Access Compliance Report Public Rights-of-Way (RR Crossings)

Intersection ID: 7486	Main Street: N_TRYON_ST	Location: N/A
ADA ID: 64BF1325B52C	Overall Compliance: No	Severity Score: 0.0
Codes/Mitigation Info/Possible Solution		Field Measurements/Component Compliance

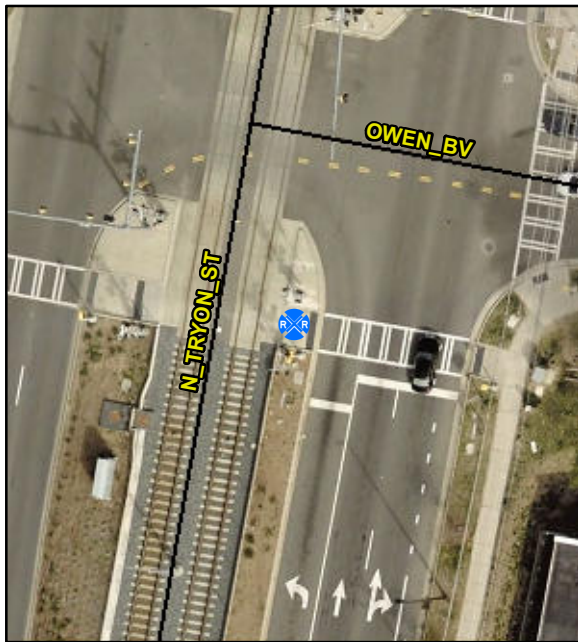
**Remove & Replace Detectable
Warning System. Provide Pedestrian
Gate. Remove & Replace Walking
Surface Adjacent to Rail.**

R302.7.4, R305.2.5

Compliance	Description	Data
Yes	DWS Provided?	Yes
Yes	DWS Contrast?	Yes
Yes	DWS Width (in)	Yes
Yes	DWS Length (in)	24.0
Yes	DWS Offset (in)	156.0
No	Pedestrian Gate?	No
N/A	DWS Outside Gate?	No
N/A	Rail Type?	LightRail
No	Flangeway Gap (in)	47.0
Yes	Sidewalk Width (in)	120.0
